CONTROL PHILOSOPHY

Checked by: V. GRABIE Function: **Technical advisor**	**Distribution :** **JLAB** **AL project team**
Written by: Gilles FLAVIEN Function: Technical Manager gilles.flavien@airliquide.com

It identifies and describes manual and automatic operations of LCLS-II 4.5K CB system.

4.2.3 CORRESPONDANCE BETWEEN TIC-22400 OUTPUT AND PV-22400 and PV022402 OPENING

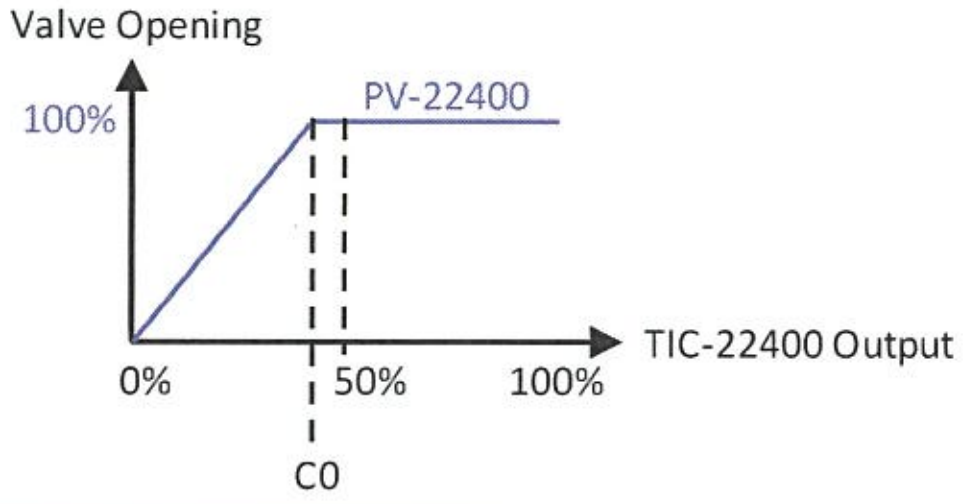
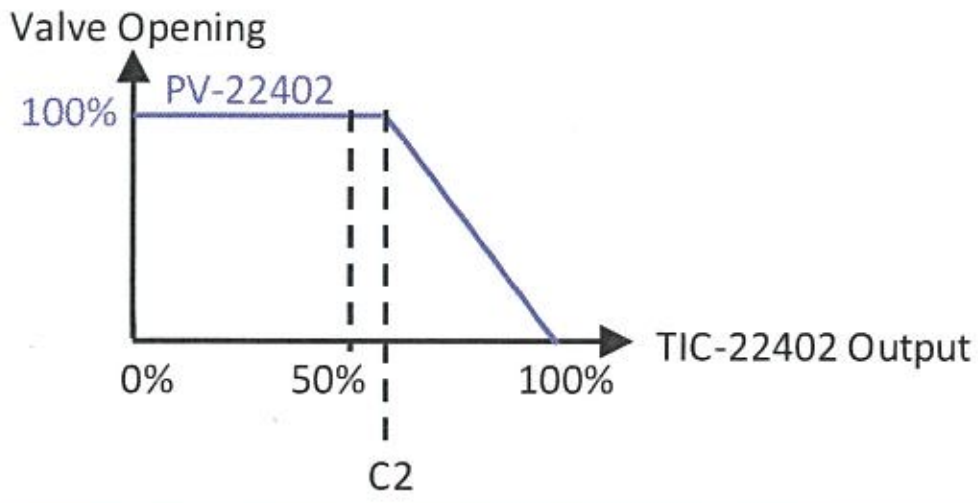
JLAB:
What is the failure position for TIC-22400 control?
- PV22402 = 100% and PV22400 = 0%?
- Or both valve 0%?

ALATUS:
Both Valves at 0%

4.5.1 PFD : Turbines Control

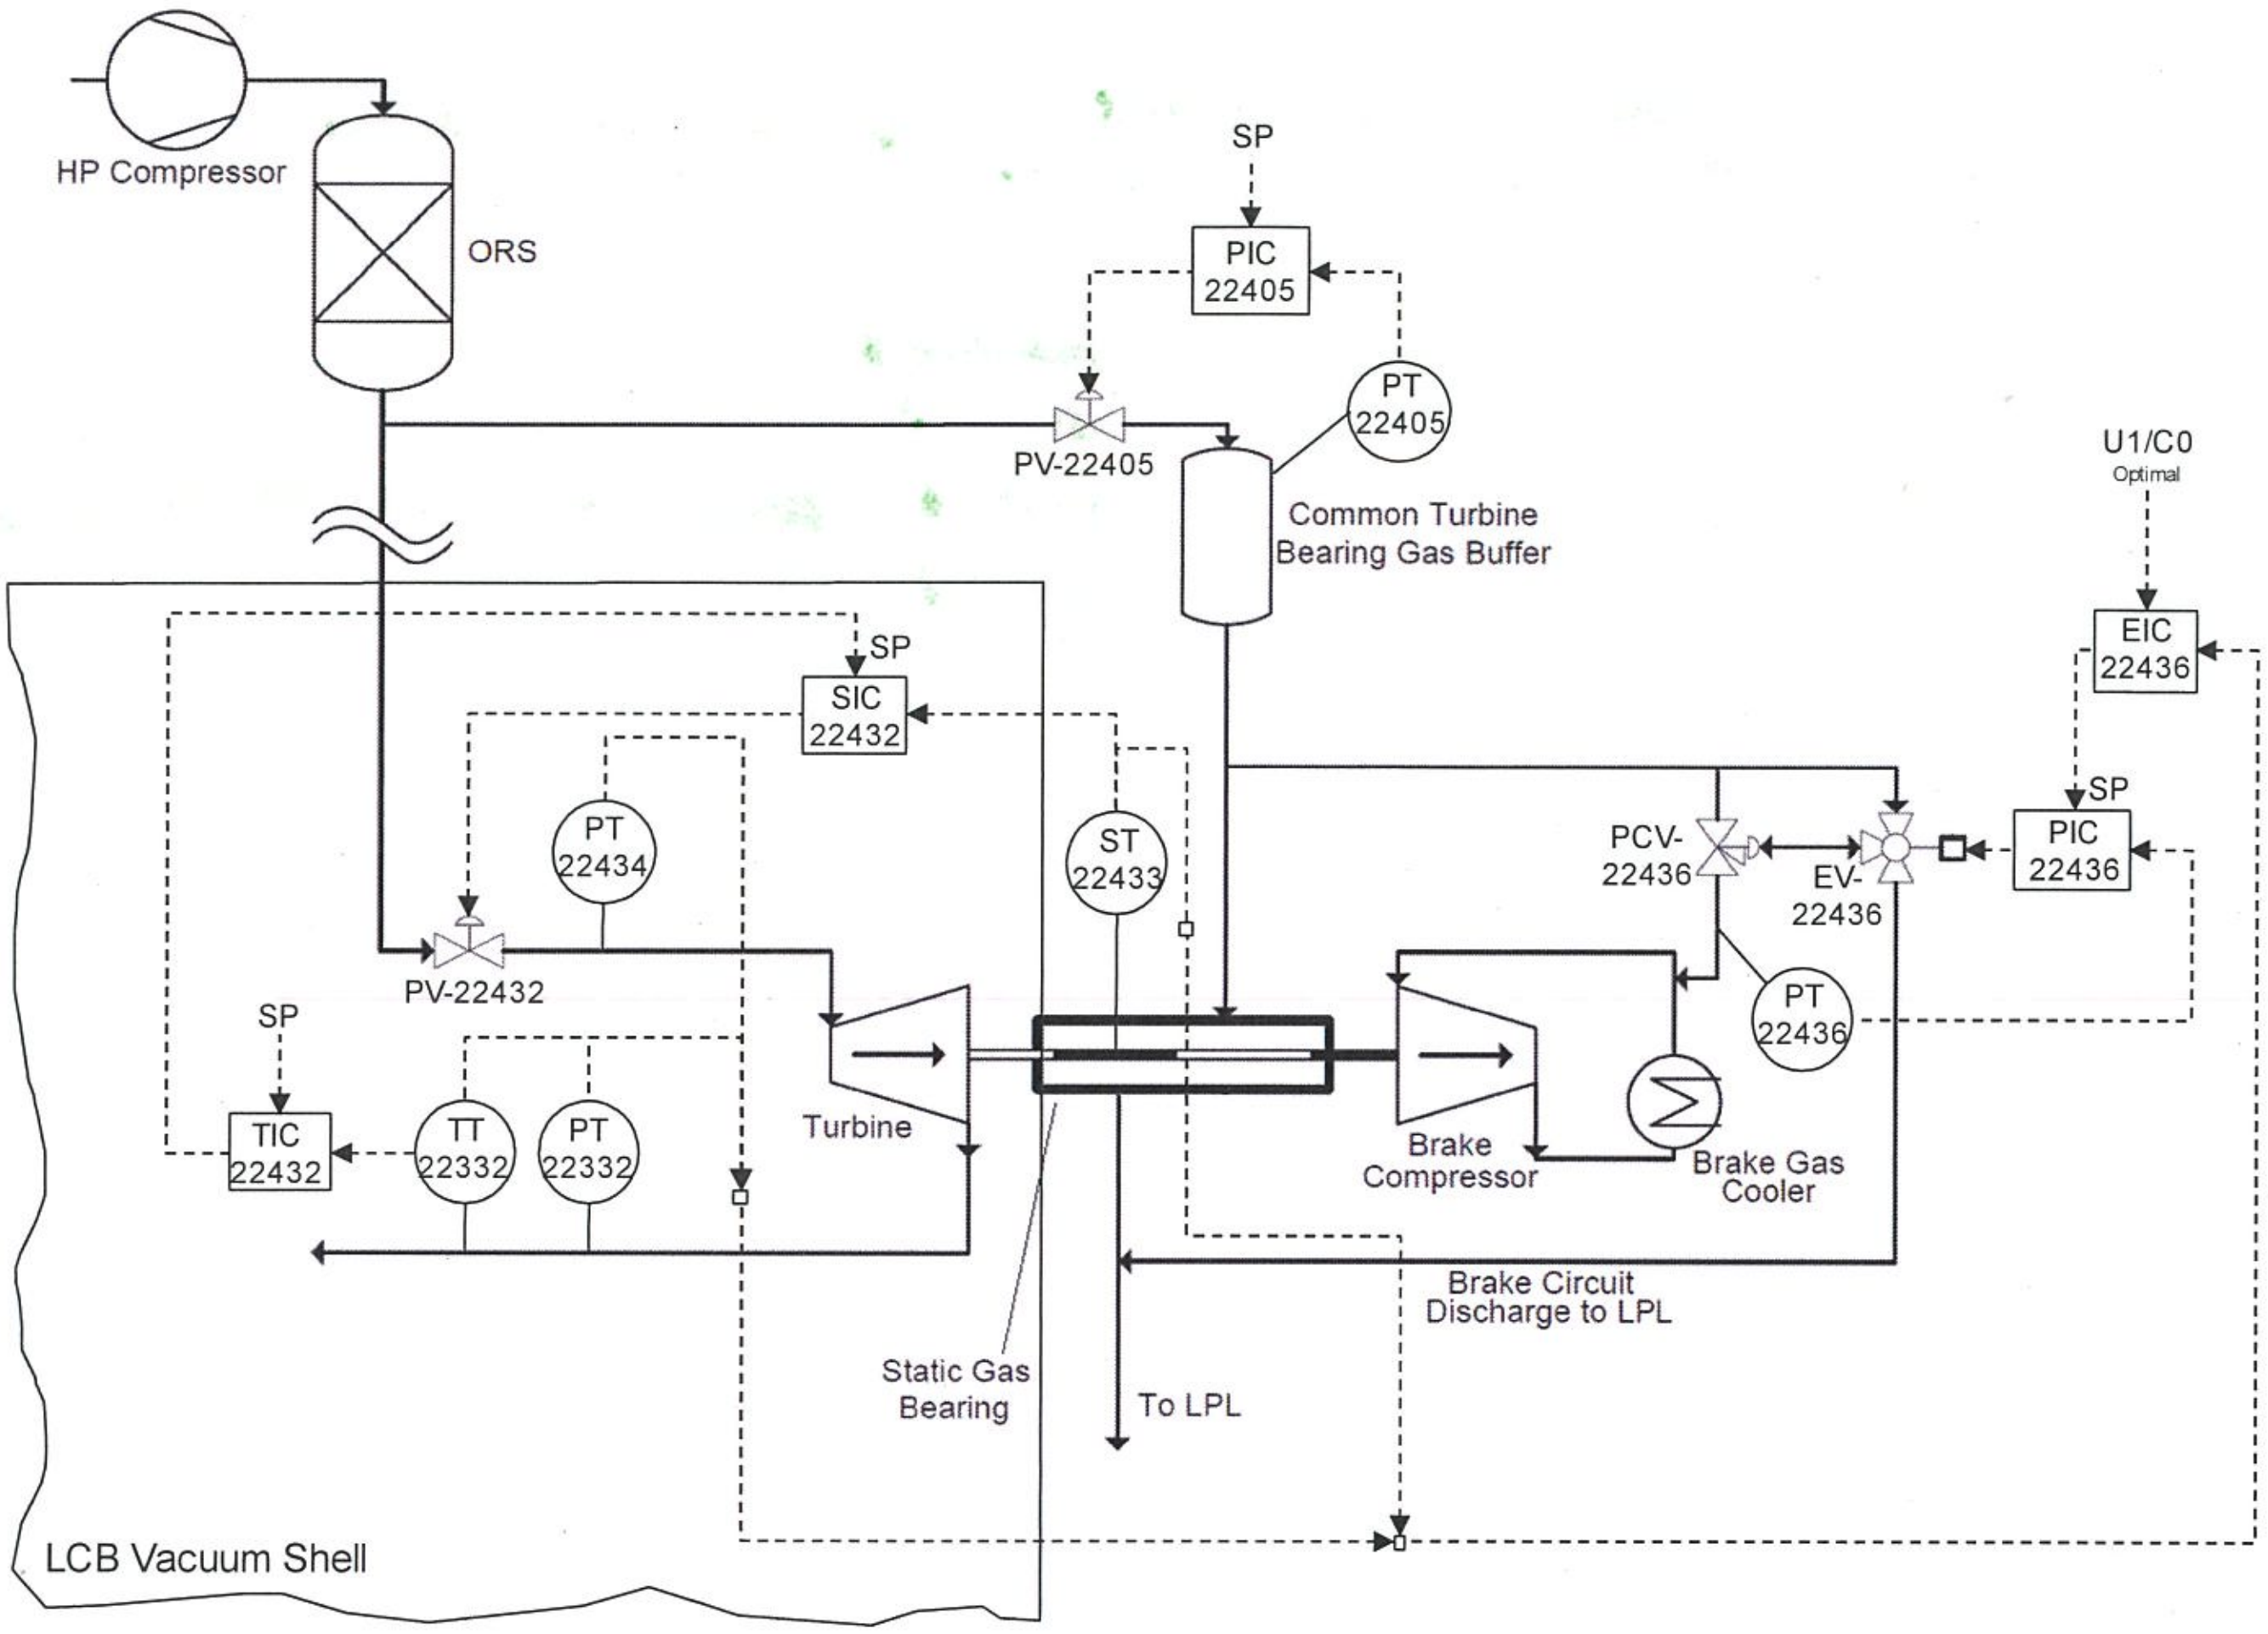
PIC22405 protector mode tested OK. Output goes to 0%.

4.5.3 SIC-224X2 & TIC-223X2 - Turbines speed

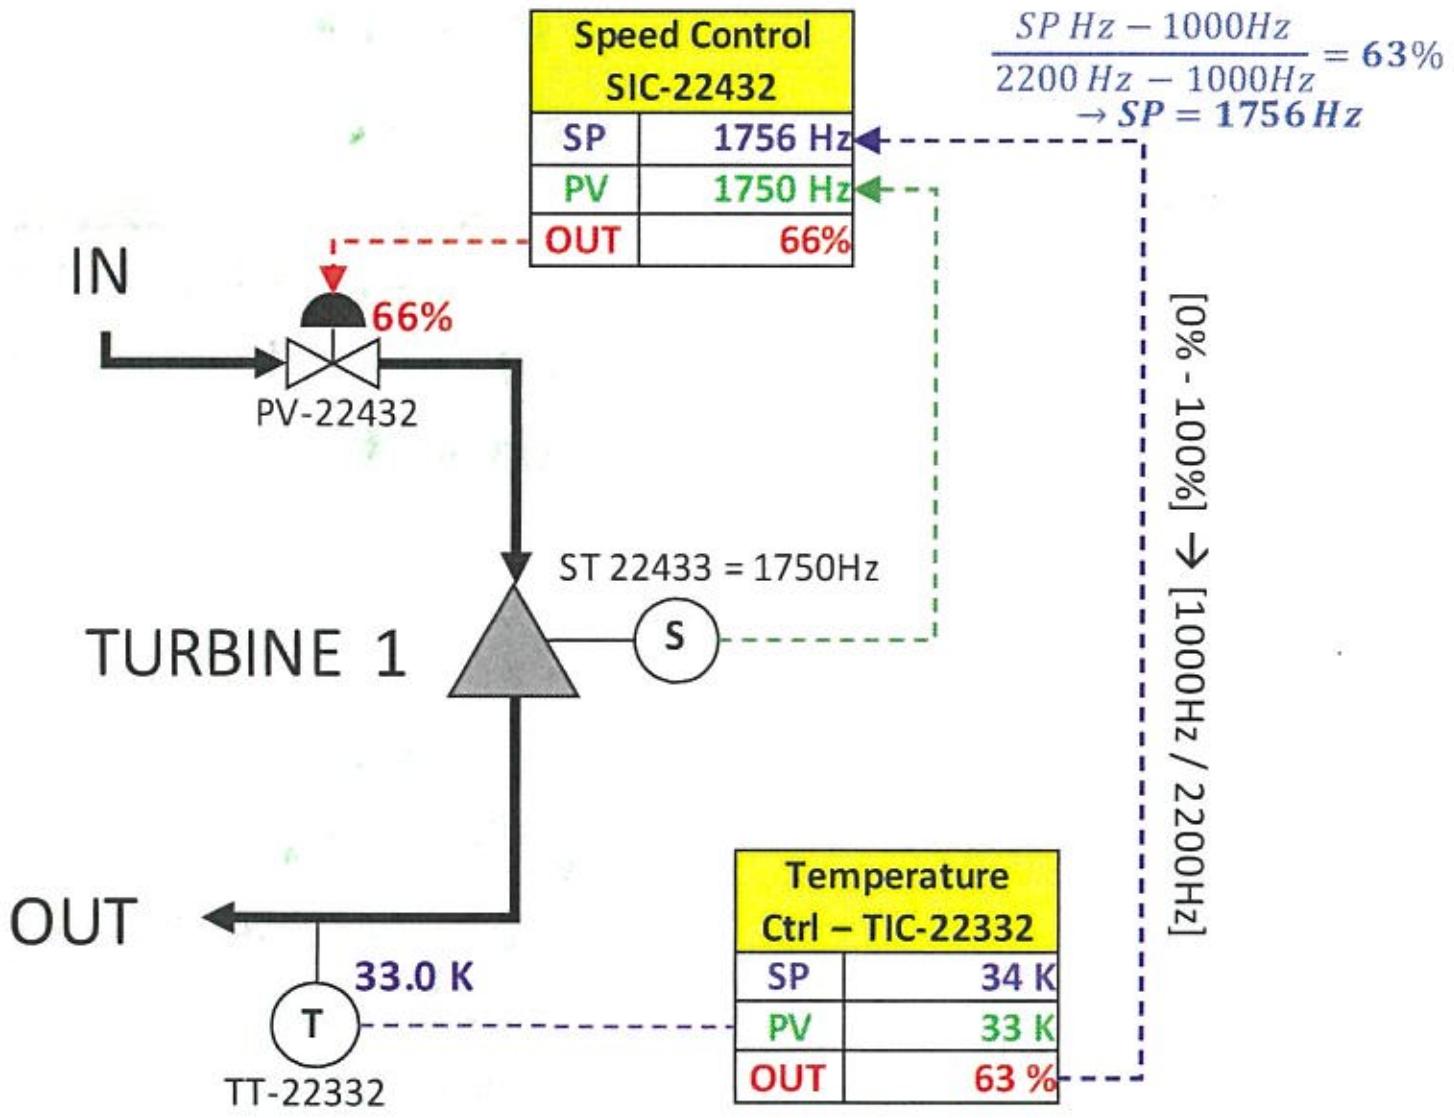
JLAB:
SIC224X2 set point = Maximum speed if TIC224X2 is OFF.
We have no scenario in control philosophy where SIC is ON and TIC is OFF.
Only situation we can think -> At X514 (turbine nominal state), if operator make TIC loop manual, and then tries to dial in a X % to go to a specific speed point.
Do we foresee this condition of TIC OFF and ramping speed up to maximum speed automatically during commissioning?

ALATUS:
I have no opinion just yet. I believe it can work in any condition with both controllers ON, but I let the window open for a possible disconnection of TIC if found necessary during commissioning
